Historic
Preservation
Commission

5:30 p.m. Tuesday
May 5, 2020
Conference Call

**National Affordable Housing Network
Request for Design Change
Empire Street Project
May 2020**

**BUTTE-SILVER BOW HISTORIC PRESERVATION OFFICE
CERTIFICATE OF APPROPRIATENESS APPLICATION**

1092 Hip Turned Posts

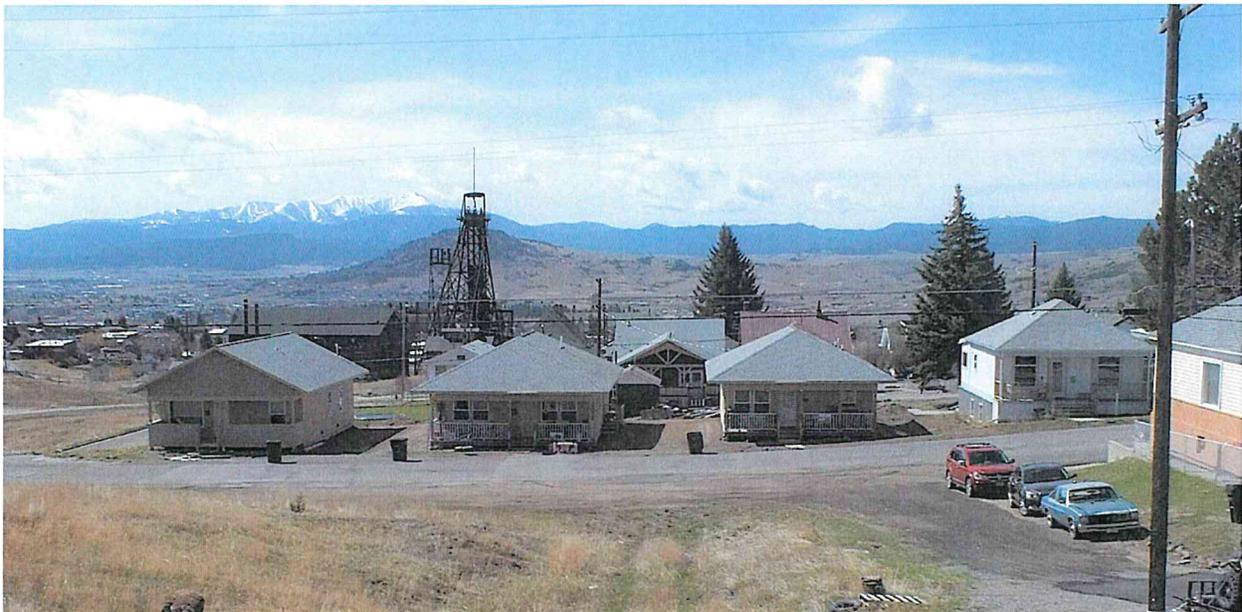
The design change is particular to the hip roofed cottage at 802 Empire. This cottage was specified to be constructed with Queen Anne-style turned posts at the front porch (see attachment). NAHN is requesting to replace use of turned post with PVC wraps in a Craftsman-style design, as follows:

The HPO consulted the State Historic Preservation Officer (SHPO) about this proposed design change. The SHPO believed it would be appropriate, if the HPC concurred.

The HPO recommends approval of this design change.

East façade, showing two-story entry porch at center. View to south-southwest

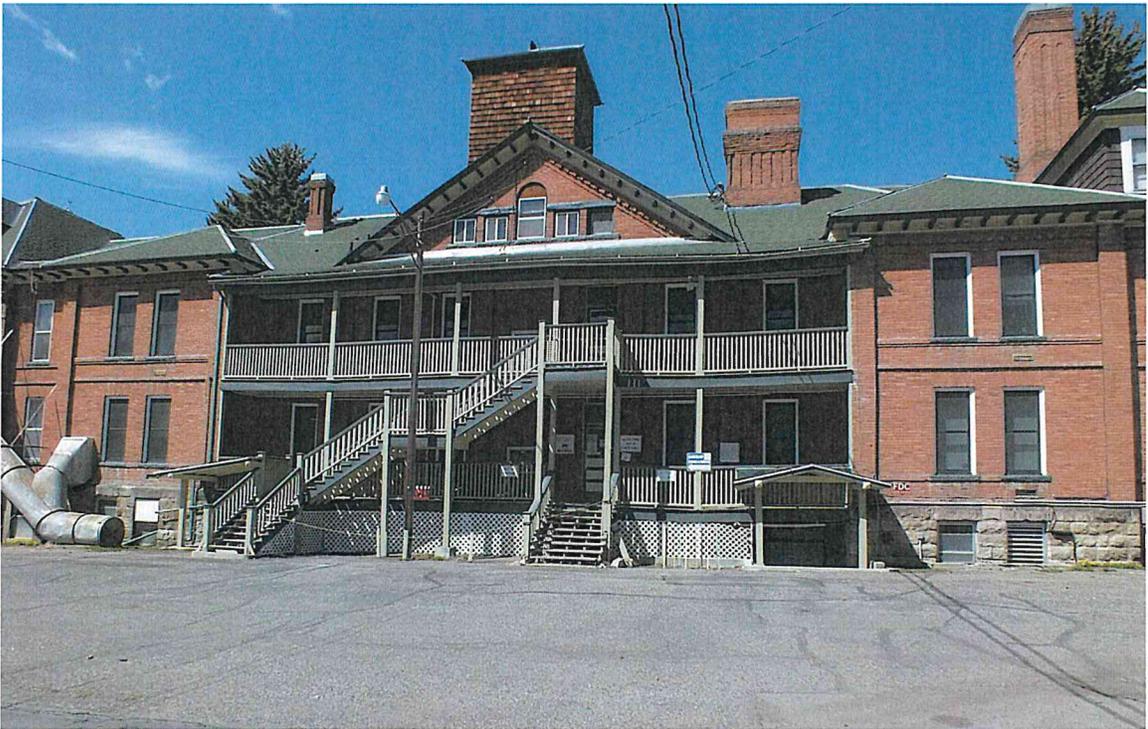
On this building, we recommend against rough-sawn wood, conspicuously visible gussets, gang-nail plates, clunky Simpson hardware, plywood. Beadboard (true beadboard or plywood with a beadboard profile) soffit on your awning and paint might hide or draw less attention to those tell-tale modern things. Maybe you can pick up whatever motifs you see elsewhere on the building. Those 4X4 ends cut to a point on existing awnings are a nice one.

On this building, we recommend against rough-sawn wood, conspicuously visible gussets, gang-nail plates, clunky Simpson hardware, plywood. Beadboard (true beadboard or plywood with a beadboard profile) soffit on your awning and paint might hide or draw less attention to those tell-tale modern things. Maybe you can pick up whatever motifs you see elsewhere on the building. Those 4X4 ends cut to a point on existing awnings are a nice one.

The Historic Preservation Officer recommends approval of the design and materials of the new porch and roofs as presented herein and incorporating the SHPO's informal comments.
